Reply to Referee #3's comments

Title: A flux tower site attribute dataset intended for land surface modeling

No.: essd-2024-77

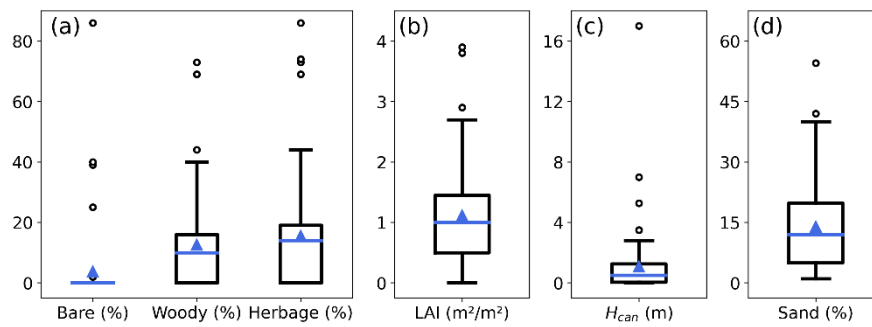
Comment 13 (L95): Were these PFT estimates cross-checked against site information e.g. from past papers? Global PFT datasets can be highly uncertain at flux towers even if provided at a high spatial resolution

Response 13: We completely agree with your suggestion. Other reviewers have raised similar concerns, indicating the need for cross-checking of filled data to quantify their uncertainties.

Accordingly, we have provided the quantification of uncertainties for the filled data. The discrepancies between site data and filled data have been added to Sect. 3.2, illustrating the uncertainties of the filled data. The added part is as follows:

Figure 4 quantifies the differences between site data and filled data at all sites for which both data sources are available, illustrating the inhomogeneities in the final dataset due to data filling. The differences in vegetation cover (including bare soil, woody, and herbaceous vegetation) generally fall within 20%, with a minority of sites exceeding 40%. The mean and median LAI differences are approximately 1 m²/m². Canopy height deviations are primarily within 2 m, although a few sites exceed 4 m. Differences in sand content typically remain within 30%, with both mean and median differences below 15%. This quantification indicates that the filled data are generally reliable across most sites.
